SI B12 08 02
Engine Electrical Systems

Engine Wiring Harness Section Replacement for Ignition Coils

E46 325i and 330i with M54 engine

E39 525i and 530i with M54 engine

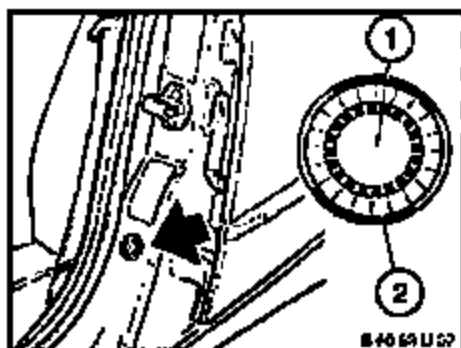
Certain 2003 model year BMW automobiles with M54 engines incorporate an engine harness that may have electrical connectors with a contact force below specifications.

Replace the engine wiring harness section for ignition coils on all affected vehicles.

Replace the engine wiring harness section for ignition coils as outlined in repair manual group 12, section 12 51 100.

Part Number	Description	Quantity
12 51 7 518 044	E46 engine wiring harness section	1
12 51 7 518 000	E39 engine wiring harness section	1
